Access Compliance Report

Public Rights-of-Way

(Curb Ramps)

Intersection ID: 10468	Main Street: E_35TH_ST	Cross Street: WHITING_AV	Location: SW
ADA ID: AEB5554A9FFE	Ramp Type: Combination1	Initial Pass/Fail: Fail	Overall Compliance: No
Severity Score: 10			
Codes/Mitigation Info/Possible Solution		Field Measurements/Component Compliance

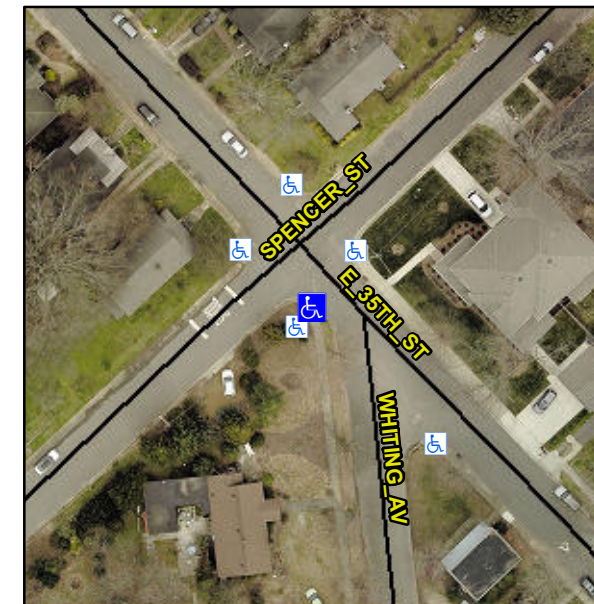
RT RP < 5%

Not Found, R304.5.1, R304.5.3

Compliance	Description	Data	Compliance	Description	Data
N/A	Ramp Length LT (in)	37.5	N/A	Ramp Length RT (in)	27.0
Yes	Ramp Width LT (in)	61.0	Yes	Ramp Width RT (in)	61.0
Yes	Ramp Slope LT (%)	7.9	Yes	Ramp Slope RT (%)	2.1
No	Ramp XSlope LT (%)	3.8	No	Ramp XSlope RT (%)	2.9
N/A	Ramp Length (in)	48.0	Yes	Ramp Slope (%)	7.2
No	Ramp Width (in)	46.5	Yes	Ramp XSlope (%)	1.0
N/A	Flare Type LT	N/A	N/A	Flare Type RT	N/A
N/A	Flare Slope LT (%)	N/A	N/A	Flare Slope RT (%)	N/A
N/A	Flare Traversable LT?	N/A	N/A	Flare Traversable RT?	N/A
N/A	Landing Length (in)	N/A	N/A	DWS Provided?	N/A
N/A	Landing Width (in)	N/A	N/A	DWS Contrast?	N/A
N/A	Landing Slope (%)	N/A	N/A	DWS Length (in)	N/A
N/A	Landing X Slope (%)	N/A	N/A	DWS Full Width?	N/A
N/A	Landing Curb? (Y/N)	N/A	N/A	DWS Offset (in)	N/A
N/A	Shared Landing?	N/A			
N/A	Gutter Ponding?	N/A	N/A	Gutter Slope (%)	N/A
N/A	Gutter Lip Ht (in)	N/A	N/A	Gutter X Slope (%)	N/A
N/A	Painted X Walk1?	No	N/A	Painted X Walk2?	N/A

Remove & Replace Entire Ramp.
